Access Compliance Report

Public Rights-of-Way

(Curb Ramps)

Intersection ID: 10024053	Main Street: CORONATION_BV	Cross Street: N/A	Location: S
ADA ID: 51DCE26E1A91	Ramp Type: PerpDiag	Initial Pass/Fail: Fail	Overall Compliance: No
Codes/Mitigation Info/Possible Solution		Field Measurements/Component Compliance	
		Severity Score: 50

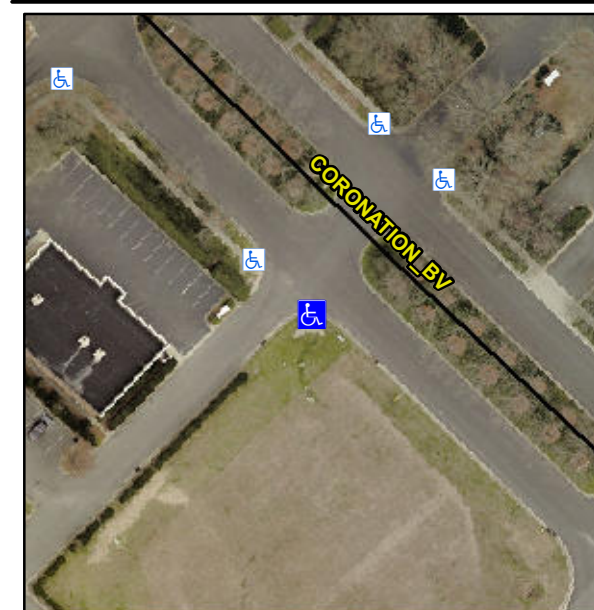
Not Found, R304.2.2, R304.5.3

Compliance	Description	Data	Compliance	Description	Data
N/A	Ramp Length (in)	98.0	No	Ramp Slope (%)	12.7
Yes	Ramp Width (in)	48.0	No	Ramp XSlope (%)	9.3
N/A	Flare Type LT	N/A	N/A	Flare Type RT	N/A
N/A	Flare Slope LT (%)	N/A	N/A	Flare Slope RT (%)	N/A
N/A	Flare Traversable LT?	N/A	N/A	Flare Traversable RT?	N/A
N/A	Landing Length (in)	N/A	N/A	DWS Provided?	N/A
N/A	Landing Width (in)	N/A	N/A	DWS Contrast?	N/A
N/A	Landing Slope (%)	N/A	N/A	DWS Length (in)	N/A
N/A	Landing X Slope (%)	N/A	N/A	DWS Full Width?	N/A
N/A	Landing Curb? (Y/N)	N/A	N/A	DWS Offset (in)	N/A
N/A	Shared Landing?	N/A			
N/A	Gutter Ponding?	N/A	N/A	Gutter Slope (%)	N/A
N/A	Gutter Lip Ht (in)	N/A	N/A	Gutter X Slope (%)	N/A
N/A	Painted X Walk1?	No	N/A	Painted X Walk2?	No
	X Walk 1 Direction	To NE		X Walk 2 Direction	To NW
N/A	X Walk 1 Width (in)	N/A	N/A	X Walk 2 Width (in)	N/A
	X Walk 1 Slope (%)	1.2		X Walk 2 Slope (%)	5.3
	X Walk 1 X Slope (%)	1.1		X Walk 2 X Slope (%)	6.1

Remove & Replace Curb Ramp With Two New Directional Ramps or Equivalent.
